# Access Compliance Report

## Public Rights-of-Way

### (Curb Ramps)

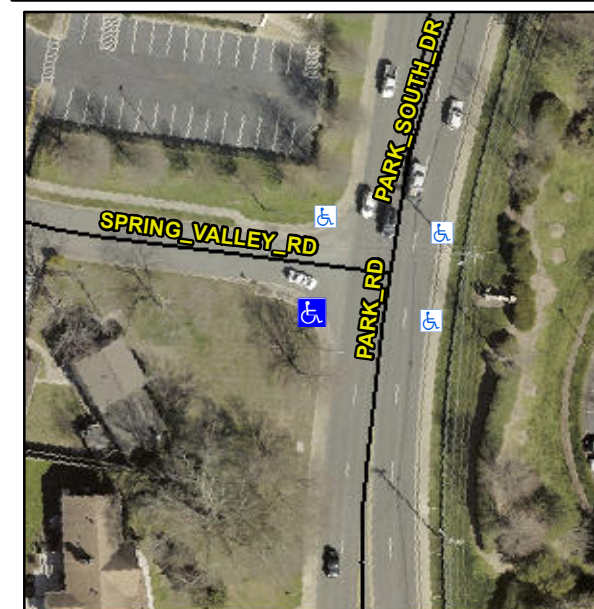
Intersection ID: 21433	Main Street: PARK_RD	Cross Street: SPRING_VALLEY_RD	Location: SW
ADA ID: 68C5B49BAF46	Ramp Type: PerpDiag	Initial Pass/Fail: Fail	Overall Compliance: No
Severity Score: 13.75			
Codes/Mitigation Info/Possible Solution		Field Measurements/Component Compliance

**Not Found, R304.2.2, R304.5.3**

Compliance	Description	Data	Compliance	Description	Data
N/A	Ramp Length (in)	54.0	No	Ramp Slope (%)	8.6
Yes	Ramp Width (in)	48.0	No	Ramp XSlope (%)	3.5
N/A	Flare Type LT	N/A	N/A	Flare Type RT	N/A
N/A	Flare Slope LT (%)	N/A	N/A	Flare Slope RT (%)	N/A
N/A	Flare Traversable LT?	N/A	N/A	Flare Traversable RT?	N/A
N/A	Landing Length (in)	N/A	N/A	DWS Provided?	N/A
N/A	Landing Width (in)	N/A	N/A	DWS Contrast?	N/A
N/A	Landing Slope (%)	N/A	N/A	DWS Length (in)	N/A
N/A	Landing X Slope (%)	N/A	N/A	DWS Full Width?	N/A
N/A	Landing Curb? (Y/N)	N/A	N/A	DWS Offset (in)	N/A
N/A	Shared Landing?	N/A			
N/A	Gutter Ponding?	N/A	N/A	Gutter Slope (%)	N/A
N/A	Gutter Lip Ht (in)	N/A	N/A	Gutter X Slope (%)	N/A
N/A	Painted X Walk1?	No	N/A	Painted X Walk2?	No
	X Walk 1 Direction	To SE		X Walk 2 Direction	To NE
N/A	X Walk 1 Width (in)	N/A	N/A	X Walk 2 Width (in)	N/A
	X Walk 1 Slope (%)	0.7		X Walk 2 Slope (%)	2.3
	X Walk 1 X Slope (%)	1.7		X Walk 2 X Slope (%)	0.8

**Remove & Replace Curb Ramp With Two New Directional Ramps or Equivalent.**
